Dynamix 2500 Data Collector, Firmware Revision 1.020

Catalog Numbers 1441-DYN25, 1441-DYN25-Z

Publication 1441-RN001B-EN-P - September 2012

Table 1 - Enhancements with Revision 1.020

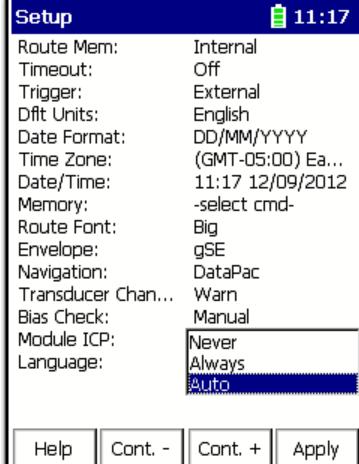
Cat. No.	Enhancement																																
1441-DYN25, 1441-DYN25-Z	A Set-up menu option for Module ICP is available.  <p>The screenshot shows the 'Setup' menu screen. At the top right, there is a battery icon and the time '11:17'. The menu lists various configuration options:</p>
